DRAWING TITLE
OVERALL UTILITY PLAN
SCALE:
1" = 10'
APPROVED: PROJECT DIRECTOR

PROJECT TITLE
SLVHCS
REPLACEMENT MEDICAL CENTER
PROJECT
LOCATION
NEW ORLEANS, LOUISIANA
DATE
02/29/2012
CHECKED
CMJ
DRAWN
ML

PROJECT NUMBER
629-HS2-401
BUILDING NUMBER
DOCUMENT SET PACKAGE
WP_08
DRAWING NUMBER
CU107

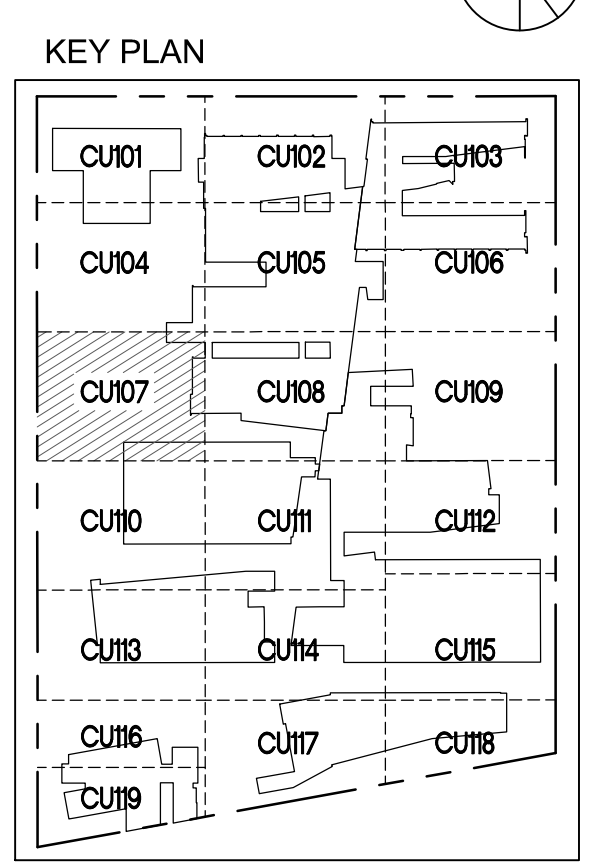
THE ELECTRICAL DUCTBANK ON THIS PAGE HAS BEEN MODIFIED. PLEASE REFER TO THE COORDINATED SITE ELECTRICAL DRAWING FOR DETAILS.

AS-BUILT INFORMATION SHOWN IN ITALIC TEXT WAS PROVIDED BY CONTRACTOR ON 04-11-2013 (RFI 01353)

SEE RFI 4099.1: MOVE DRAIN LINE AND STRUCTURE NORTH TO LINE UP WITH DRAIN LINE COMING OUT OF D&T

RFI:01308 - Pipe Elevation Changes
